**Meeting Date:** Tuesday 10 May 2016  
**Location:** Committee Room 2, Level 5, Civic Centre, 1 Devlin Street, Ryde  
**Time:** 5.00pm

**NOTICE OF BUSINESS**

<b>Item</b>		<b>Page</b>
1	CONFIRMATION OF MINUTES - Meeting held on 12 April 2016.....	1
2	38 CONRAD STREET, NORTH RYDE. LOT 23 DP 222878. Further Report. Section 96 application (MOD2015/77) to modify development consent LDA2011/343 for alterations and additions to dwelling. ....	9
3	58 DENISTONE ROAD, DENISTONE. LOT 19 SEC 4 DP 7997. Local Development Application for demolition, construction of two storey (with attic above) new child care centre with 46 places, 11 car parking spaces, fencing and business identification signage. LDA2015/0209. ....	129

**Site Plan showing location of the physical separation barrier for pedestrian pathway**

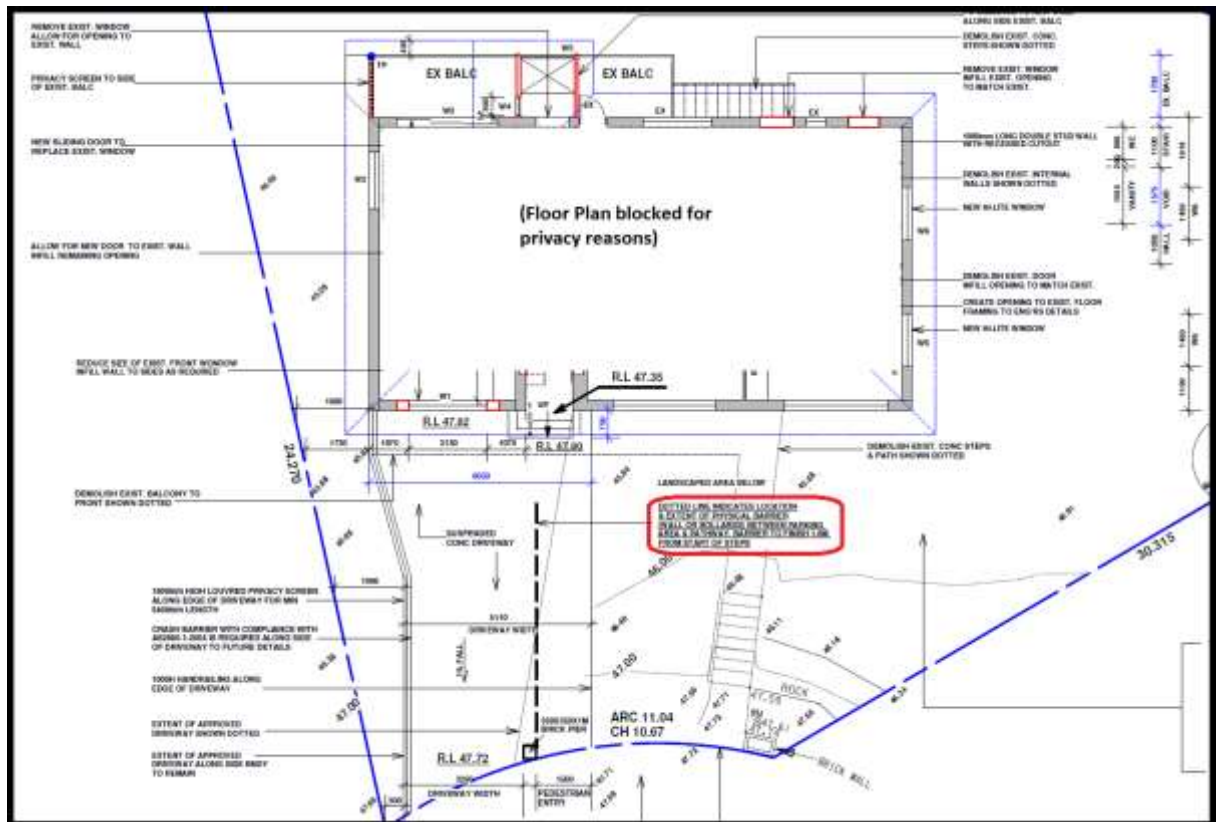
- **Pedestrian Pathway** – A physical separation barrier in the form of a wall/bollards has been noted and placed between the pedestrian and driveway components of the elevated structure to ensure pedestrians visiting the dwelling house are guided away from the northern boundary that is common with the adjoining property at No.36 Conrad Street. This is shown on the site plan below:

**Pedestrian Pathway** - Physical separation be placed between the pedestrian and driveway components of the elevated parking structure via a low level wall, bollard, or planter etc. Plans detailing compliance with this condition are to be submitted to Council for approval prior to the issue of a **Construction Certificate** works covered in the plans under Condition 1.

**Figure 3** – Extract of elevation from stamped plans of LDA2011/0343 showing the approved elevated driveway structure connecting to the garage on the upper floor of the dwelling.

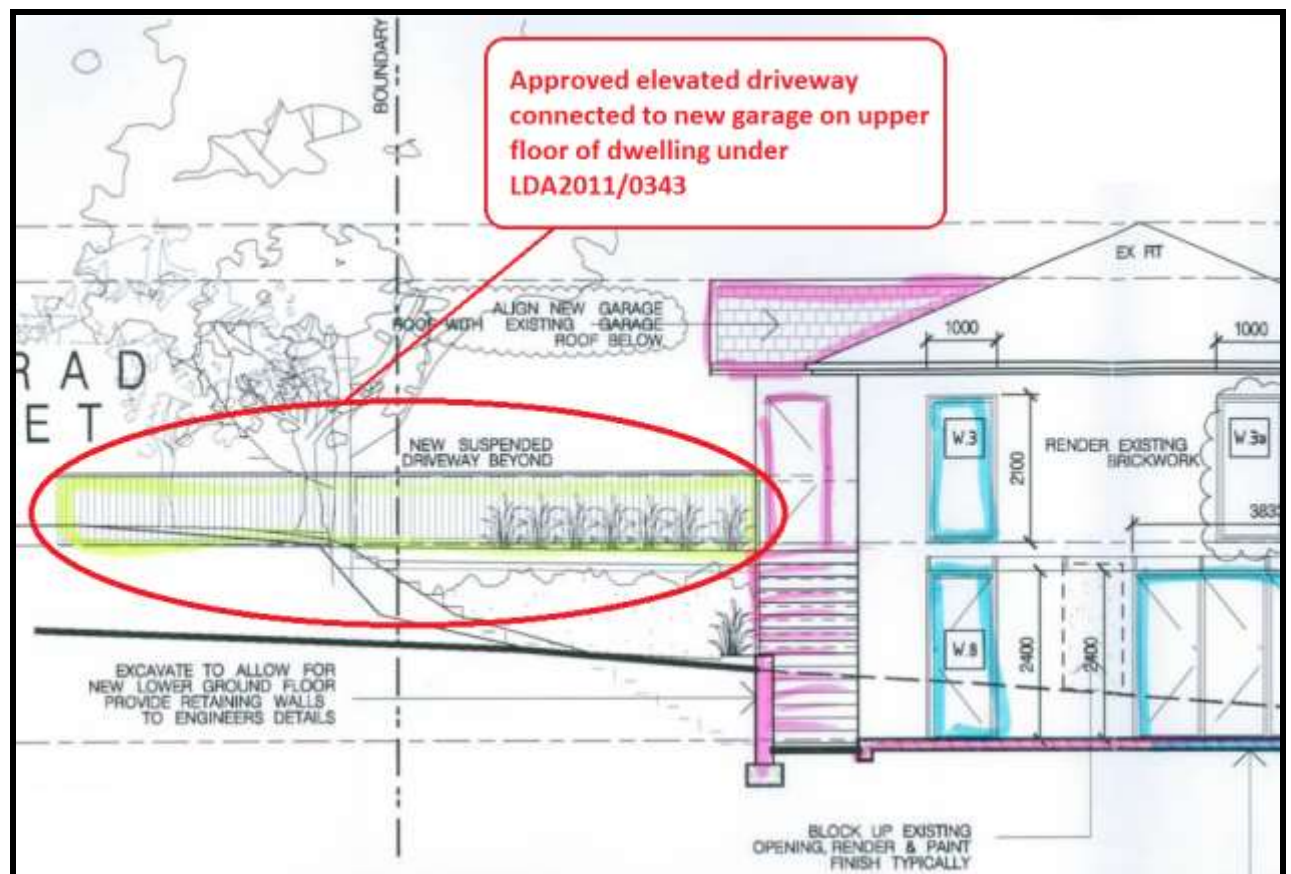
The original DA was approved subject to conditions on 29 November 2011. Importantly for the subject Section 96 application, the DA approved an elevated concrete driveway structure extending from the street frontage to a new garage located on the upper floor of the dwelling house – refer **Figure 3** below.

**Figure 4** - An alternative driveway design submitted by the objectors.

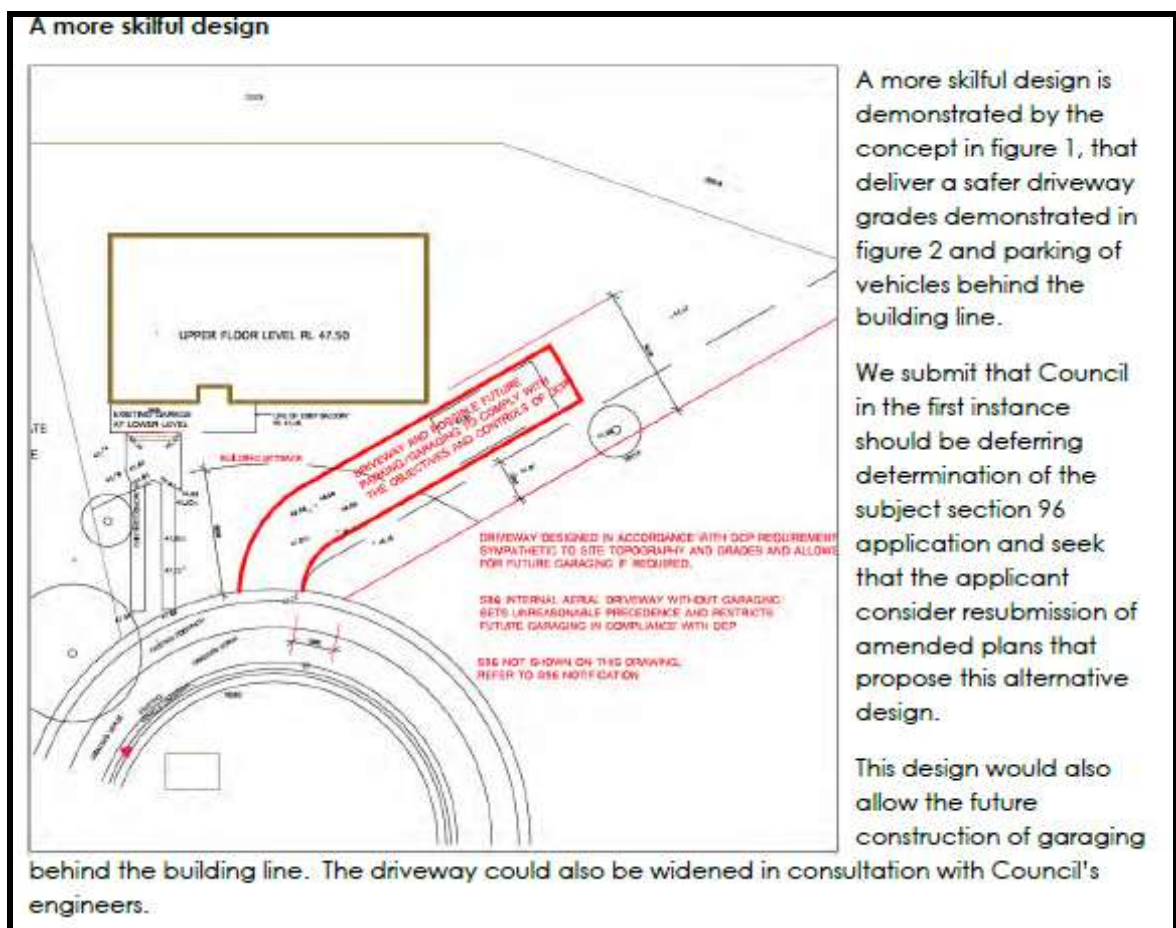
**Assessment Officer Comment:** The alternative design suggested by the objector was put to the applicant in a meeting on 3 August 2015 - refer **Figure 4** above. The applicant advised that this is not feasible because site preparatory works have already been undertaken including the construction of retaining walls which would conflict with this alternative arrangement.

Figure 5 - Proposed 1.8m privacy screen provided for 5.4m (standard car space length) from the building façade. Note the carport is not approved, but the balcony privacy screen is considered acceptable.

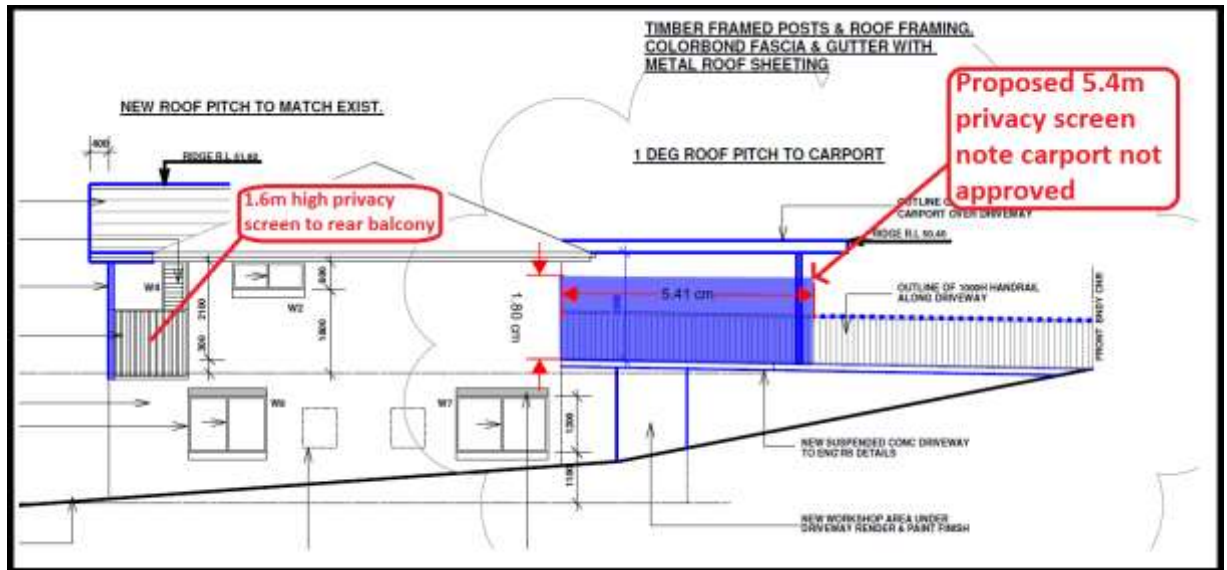
**Assessment Officer Comment:** The revised plans (see **Figure 5** above) now detail setbacks that are generally consistent with the originally approved development. These are now proposed to be 1900mm (1.9m) at the widest point and 500mm from the northern boundary (at the front boundary). Given the angle of the allotment's northern boundary it is considered that the existing setbacks approved by the original development are generally appropriate and that setting the structure 2m for its entire length would require additional internal and external changes to the development that would be onerous.

**Assessment Officer Comment:** In respect to recommendations under number 4 from the objector, a condition has already been discussed and is proposed for a 1.8m high privacy screen to address potential overlooking from the elevated structure. This screen will help minimise overlooking given the new use of the structure as a parking platform rather than a driveway. This is shown in **Figure 5** above.

In respect of the proposed 1.6m privacy screen to the rear facing balcony, this is considered an appropriate privacy treatment and it is not considered necessary to raise this to 1.8m. This is because the average eye level of a person is closer to 1.6m rather than 1.8m. The 1.6m high rear balcony privacy screen is also shown in **Figure 5**.

In this regard it is considered that the following condition requiring this 1m fence be increased 1.8m for just 5.4m (standard car length) be imposed to maintain visual privacy whilst also reducing the visual bulk and scale of the structure. The Northern Elevation drawing, edited to show the required 1.8m high privacy screen (5.4m long), is shown at **Figure 5** (above).

Figure 6 – Plan showing side setbacks of proposed driveway.

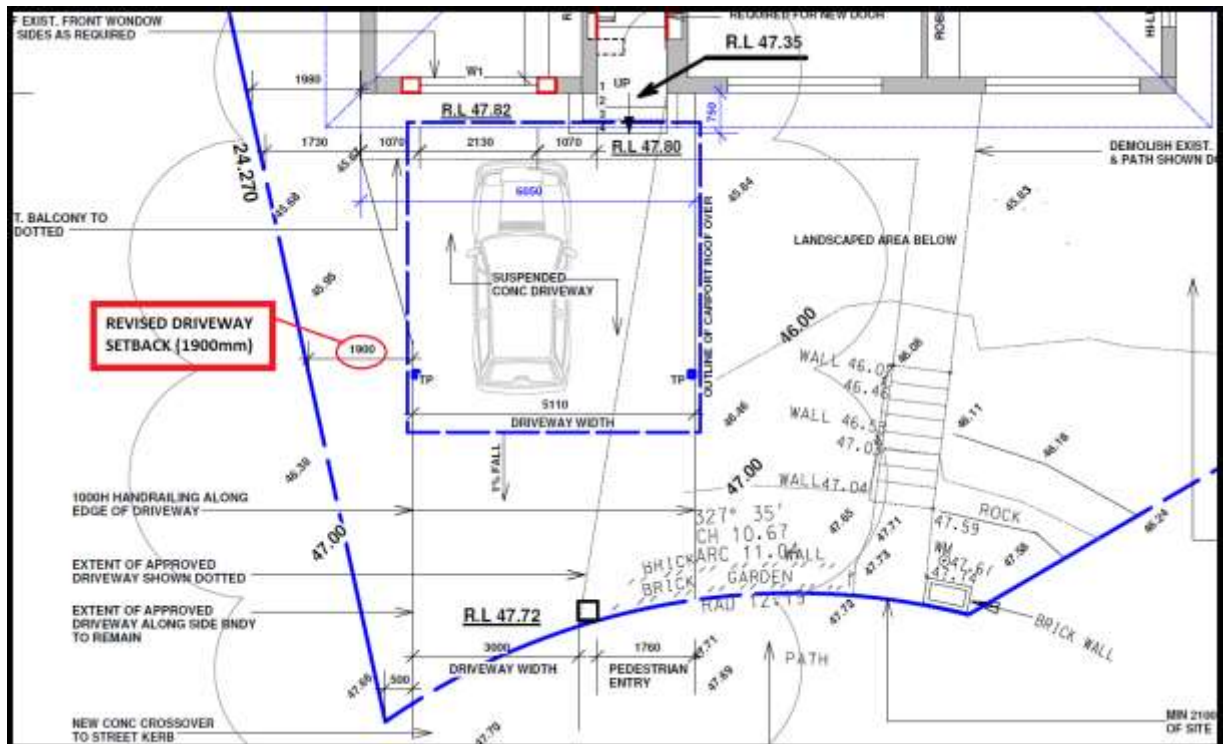
Revised plans were received by Council on 14 August 2015 (and then further amended following a Council request for additional detail on 2 September 2015). These plans illustrate the elevated structure's setback to the northern boundary being more consistent with the setback shown on the original approved DA plans. In addition it is noted that the driveway has been extended to the south to incorporate a more legible pedestrian entry, with separation provided by virtue of a wall at the driveway crossover. A plan of the driveway showing the revised setback of the driveway is shown below.

A measurement of the revised plans has revealed that the structure can now only accommodate parking for one (1) vehicle according to the minimum dimensions provided within the DCP2014, which are based on the Australian Standard.

**Figure 9** - Northern elevation windows with indicative location of existing 1.8m boundary fence considered acceptable for maintaining visual privacy from the ground floor windows.  
Source: submitted architectural plans edited by CPS

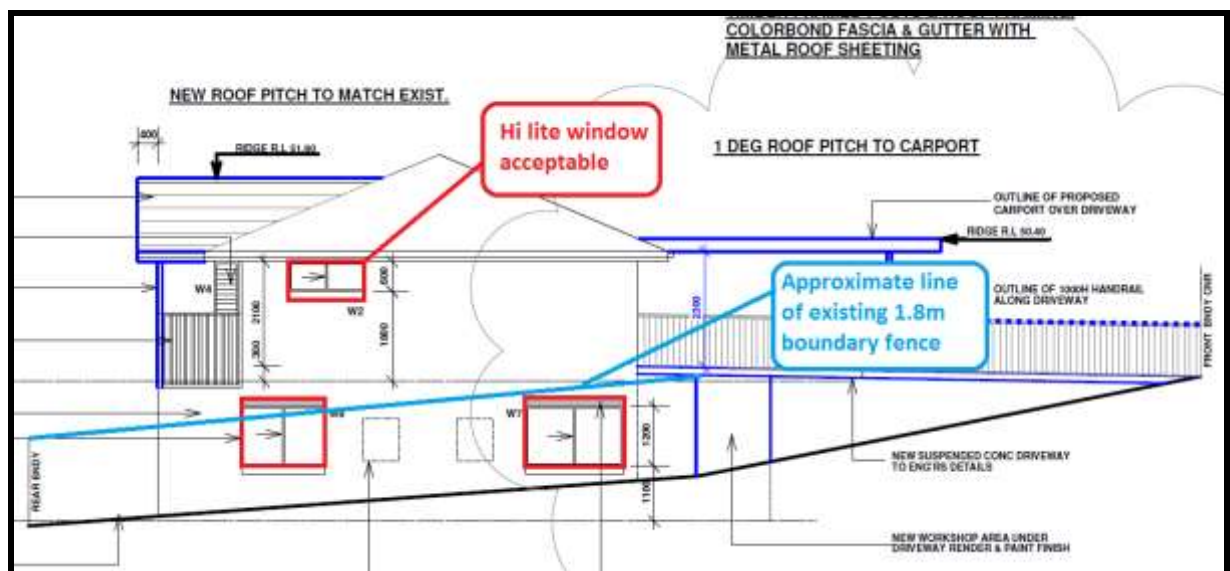
- I. **Visual Privacy – Windows.** All north facing windows to have a minimum window sill height of 1.7m above the finished floor level unless fixed and translucent glazing is provided.

**Assessment Officer Comment:** An analysis of the proposed windows on the northern elevation has revealed that the first floor window is a highlight window with a sill height of 1.8m. The ground floor windows are considered to be acceptable - refer **Figure 9**. This is because there is currently a 1.8m boundary fence which will prevent overlooking into the neighbouring private open space. Further an analysis of the southern elevation of the adjacent dwelling reveals that living area windows are located at the first floor and due to the site orientation, these windows face the street frontage and front setback areas of No.38 Conrad Street not the side boundary.

**Figure 11** - Workshop shown within the envelope of the driveway and 6.5m from the front boundary.  
 Note that the door to workshop opens to the south and that no windows are proposed.  
**Source:** Submitted plans by applicant edited for diagrammatic purposes by CPS.

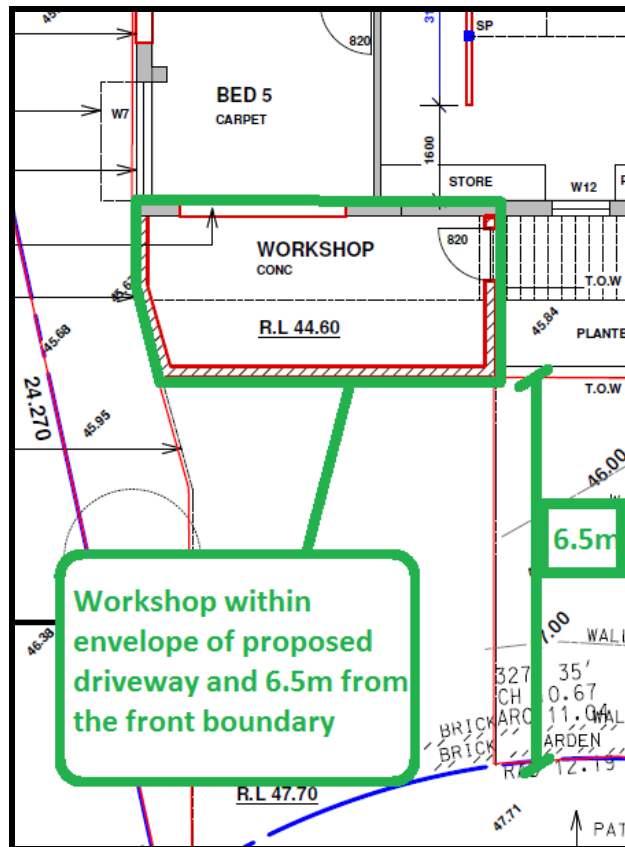
Whilst workshop is part of a structure that could be considered a visually prominent element within the streetscape, it is noted that a structure is already approved and if constructed would have a similar visual prominence. Nevertheless it is considered that the proposed workshop within the envelope of this structure does not necessarily increase its visual prominence - refer to **Figure 11** below.

PART PLAN DA+03 REVISION C:  
COLOUR OVER LAY TO SHOW ELEMENTS OF THIS S96

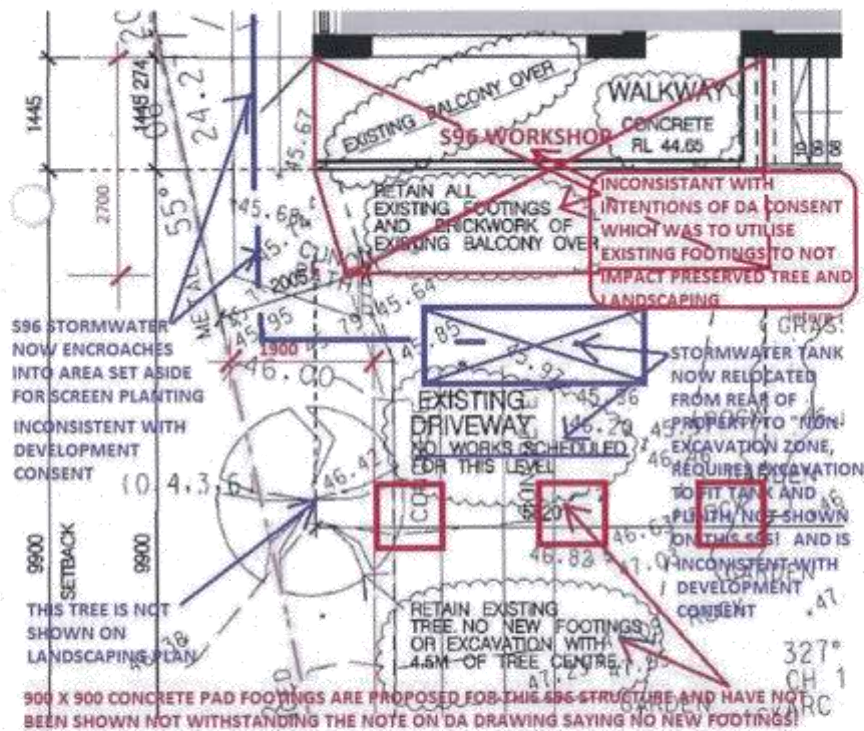
conditions of the original consent. The CC drawings on which this S96 attempts to regularise is inconsistent with the intentions of the development consent.

The Engineering drawings of the inconsistent Construction Certificate must form part of this S96 to enable assessment from the perspective of complying with the intentions of the development consent (which the function of the AC in the situation of assessing this S96 is not party to).

As the S96 Application states: "If these amendments involve changes to the design, the application **must** include copies of plans that show these changes " and "all relevant supporting documentation that justify the change/s." "must" be submitted.

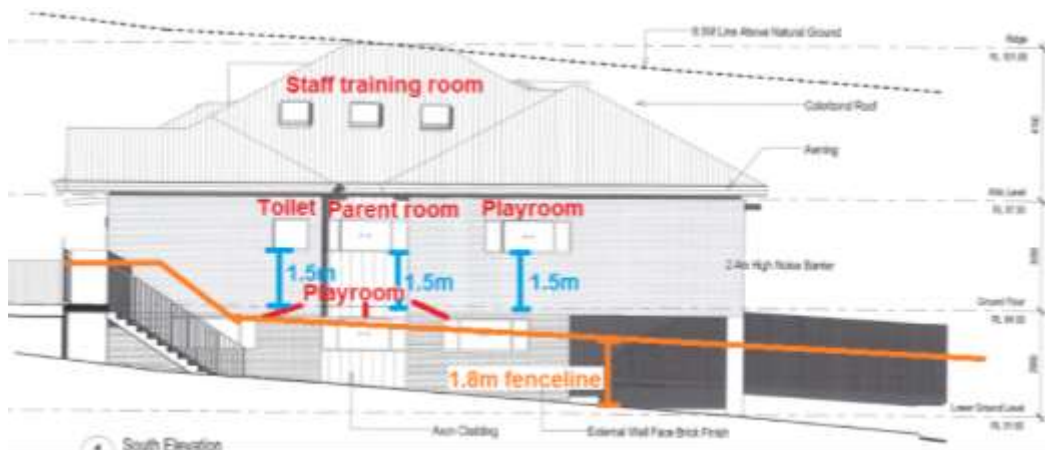
- E. Privacy.** *Concerns are raised that the stairs on the southern side will allow overlooking into No. 60 Denistone Rd. Further, the upper level of this centre has windows on side elevations overlooking onto adjoining properties.*

Therefore, having regard to the above, it is considered that the proposed fencing will be acceptable in terms of impacts on the neighbouring property. The following condition of consent will be imposed on the consent (condition 1(e)).

- *All Perspex material fitted on top of boundary fencing is to be frosted to prevent overlooking.*

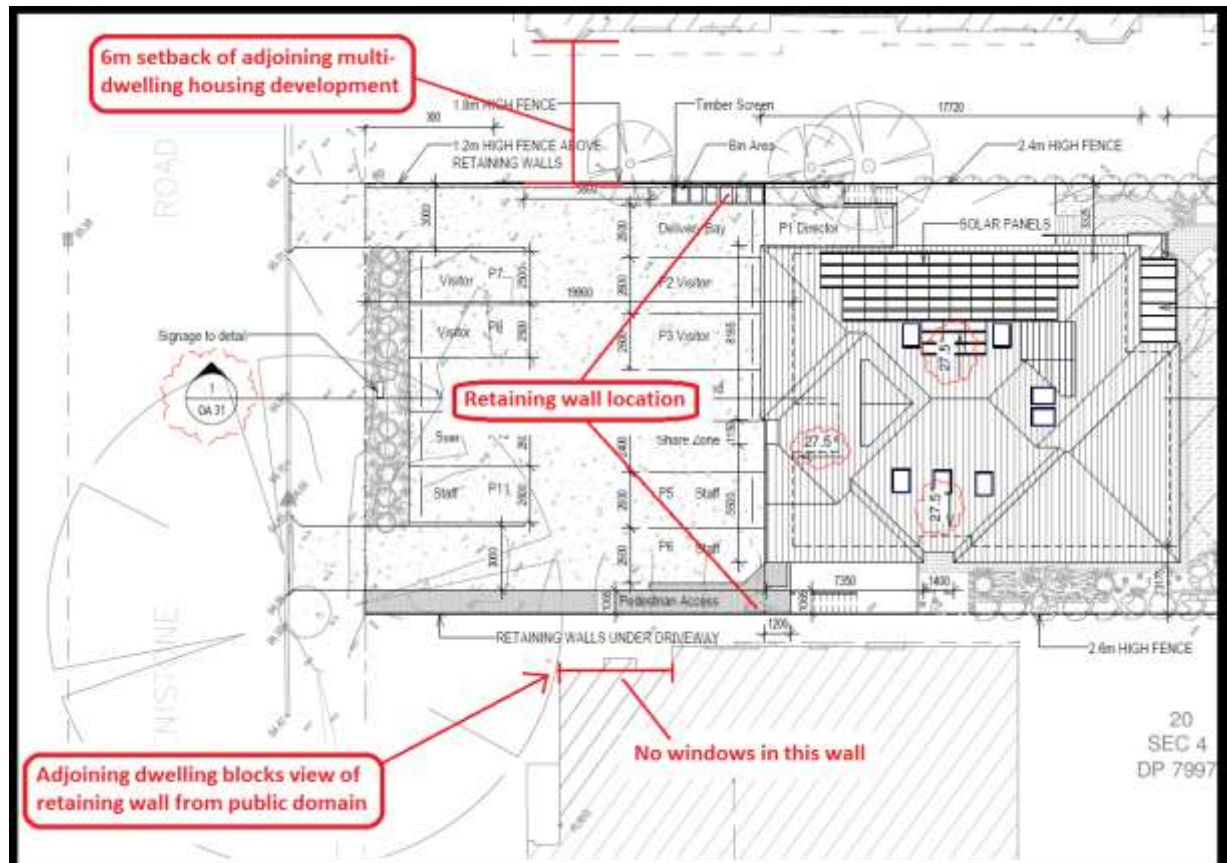
**J. Retaining Wall & Fencing.** *Concerns are raised that the boundary fencing exceeds the allowable suburban residential limit. Further, the retaining wall on the property boundary reaches 1.7-1.9m in height which will have an adverse impact to adjoining properties. The addition of a 1.8m high boundary fence on top of this retaining wall is not in scale or character with adjacent properties.*

A retaining wall along each side boundary is necessary to accommodate the stairway connecting the car park to the outdoor play areas. The retaining wall will only be visible to the front of the development where the carpark will be located (as shown in the drawings of the “southern boundary fencing” and “northern boundary fencing” above). From there, it will be below ground level towards the rear of the property, and then 1.8m high boundary fence (with 0.8m-0.95m Perspex on top) will be the only elements seen from both the multi dwelling housing development at No. 56 Denistone Road and the dwelling house at No. 60 Denistone Road.

Where the retaining wall is at it’s highest is on the southern side (as shown in the above drawing). The retaining wall will be mostly unable to be seen from the public domain because of the position of the adjoining dwelling on No 60 Denistone Road. There will also be minimal impact on this dwelling itself, because the room at the front of this house does not contain any windows.
